**15027: Dover High School and Career
Technical Center**
25 Alumni Drive
Dover, NH 03820

Change Request Proposal 190012

Title **RFI-009 Organic Material at Loading Dock**
Date Issued **19-Sep-2016**
Proposal Status **Submitted**

REMOVAL OF ORGANICS
Points and Quantity

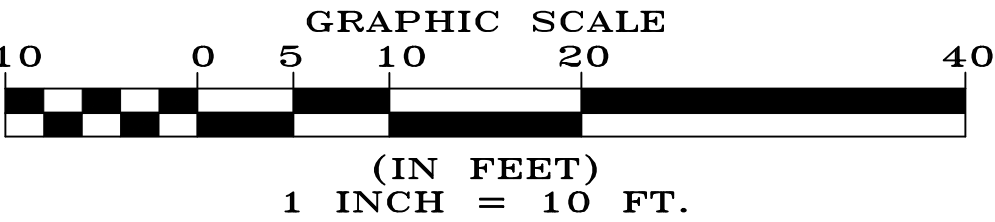
Cut Volume: 969.477 C.Y.
Fill volume: 0.0 C.Y.

Max Cut: 8.873 at 1192622.051,247925.211
Max Fill: 0.000 at 1192584.264,247861.865

Area in Cut : 6,199.3 S.F., 0.14 Acres
Area in Fill: 0.0 S.F., 0.00 Acres
Total inclusion horiz area: 6,199.3 S.F., 0.14 Acres
Total inclusion slope area: 6,854.4 S.F., 0.16 Acres

Average Cut Depth: 4.01 feet
Export Volume: 969.477 C.Y.
Elevation Change To Reach Balance: 4.015
Volume Change Per .1 ft: 23.0 C.Y.
